PJM Manual 12: Balancing Operations v52 Revision Summary

Markets & Reliability Committee
February 22, 2024

M-12 Version 52 Revisions

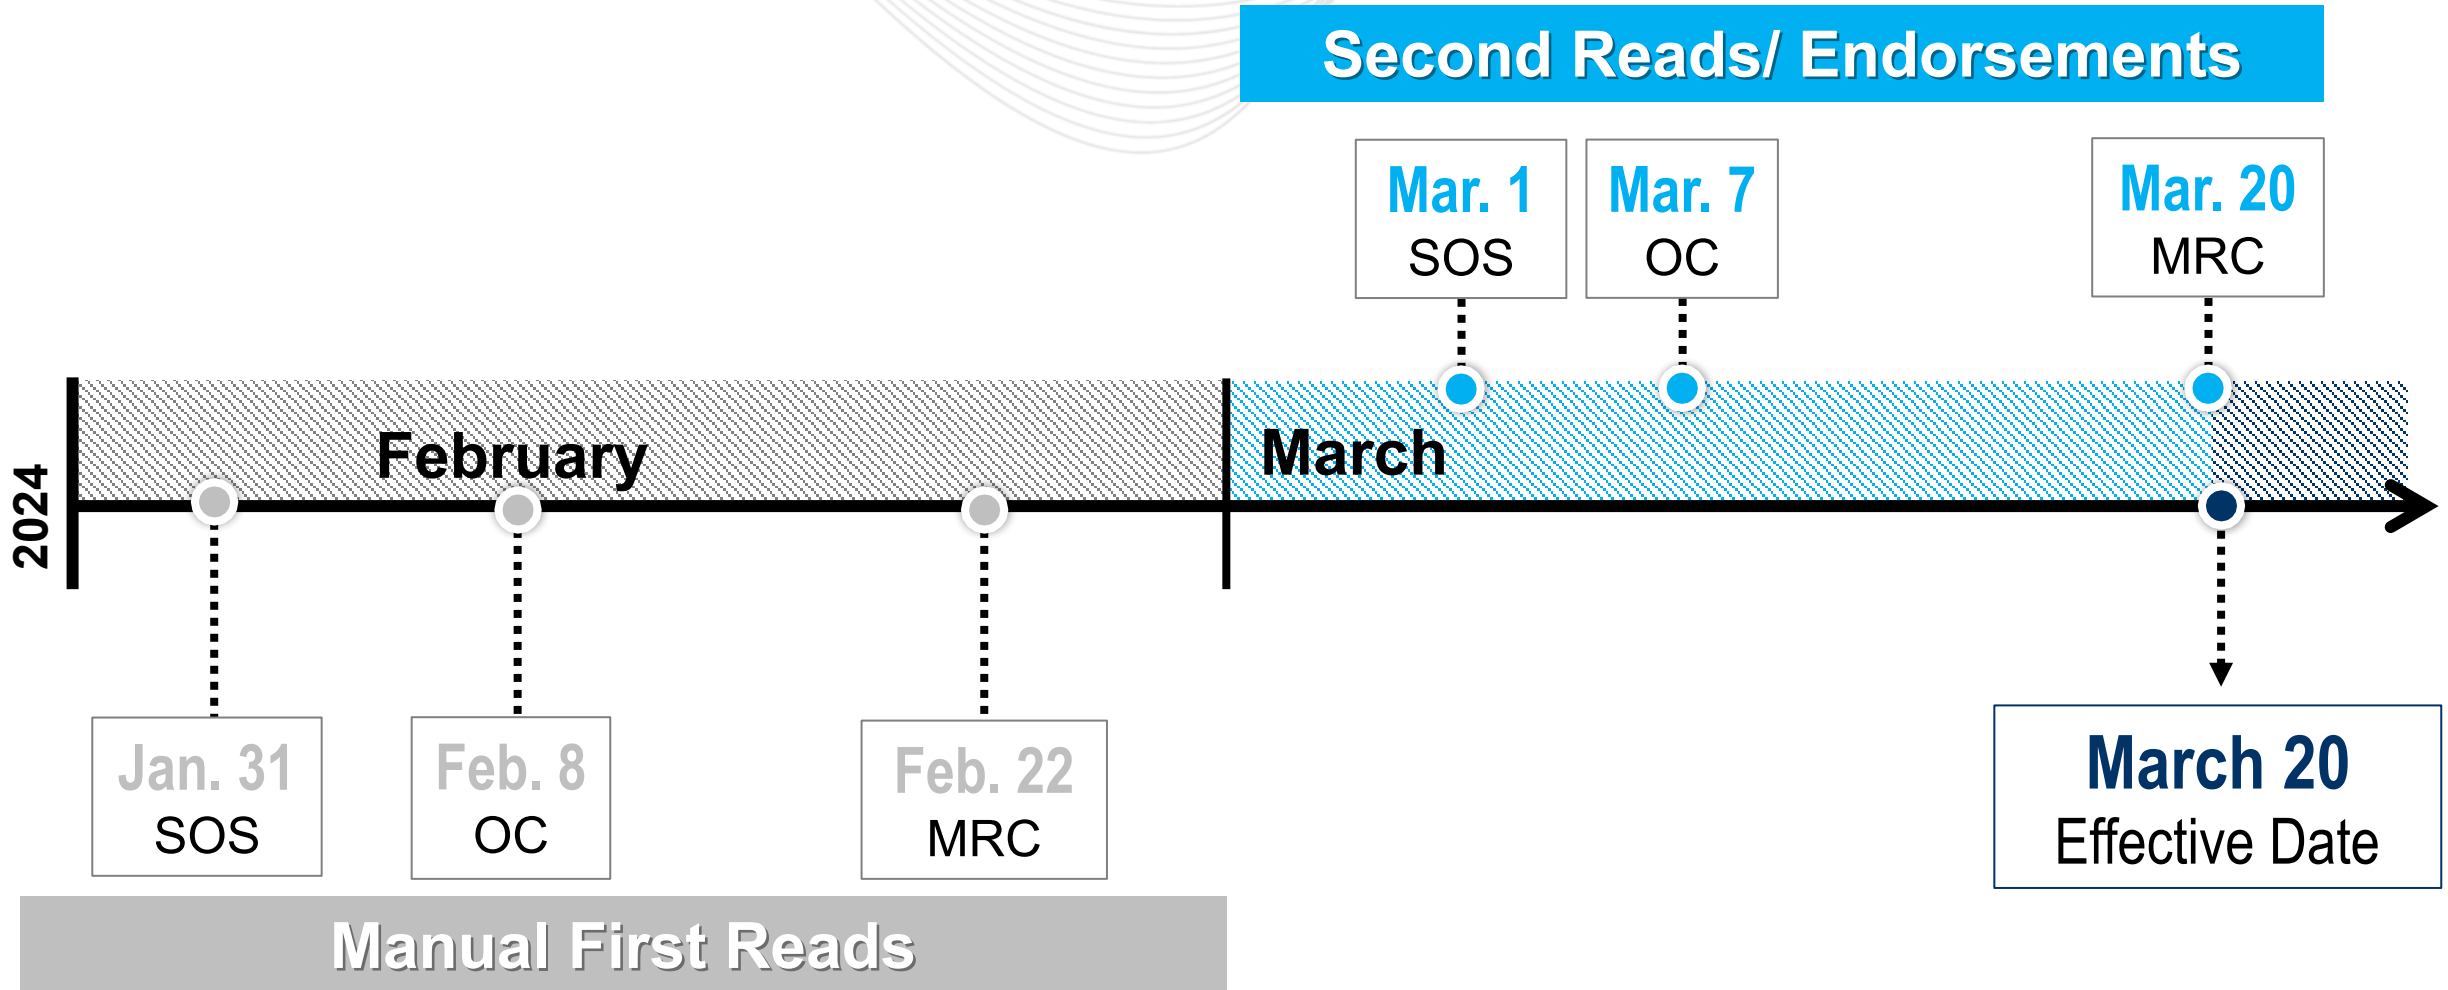
- Notes modified to include hybrid resources

3: An intermittent or hybrid resource's Economic Minimum shall represent the lowest operating MW point of the resource.

4: An intermittent or hybrid resource's Emergency Minimum should be set to 0.

- Notes added

- Note 5: The output of a hybrid resource should achieve its dispatch point within 5 minutes or consistent with the resource's ramp rate bid. PJM should be notified if the response time is expected to exceed 5 minutes
- Note 6: : The operator of a hybrid resource that is dispatchable must indicate to PJM the hours for which the plant is operating in "intermittent-only" mode, during which time the battery is not providing power for the purpose of maintaining hybrid output consistent with PJM dispatch. Dispatchable hybrids must follow dispatch in both "intermittent-only" mode and all other hybrid modes.
